Subject: TIB 34-060 - T680/T880 Cab Fuse Box Enhancement

# **Technical Information Bulletin**

#### 34-060

T680/T880 Trailer Power Polyfuse Overheating

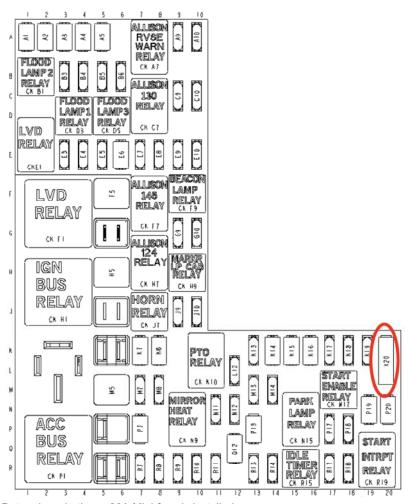
The Cab fuse block may have a polyfuse switch installed in the Trailer Hot line/Trailer Power circuit (position K20) on vehicles equipped with a seventh wire Trailer Power option.

- 1. Review the attached chassis list for your dealer code and schedule your customer(s) for service if their chassis is on the list.
- 2. Review the DWWC or SIR for "Complete" next to the "34-60" campaign code prior to performing this repair.
- 3. Follow the procedures below to replace the polyfuse with a standard fuse at location K20 of the fuse box.

- 1. Locate the Power Distribution Center (Fuse Box) behind the kick panel close to the driver's left foot.
- Locate the Trailer Power fuse position K20.

- Determine whether a 30A Mini-fuse is installed.
  - If a 30A Mini-fuse is installed, do not replace it.

If a Poly-fuse is installed, replace it with a 30A Mini-fuse.
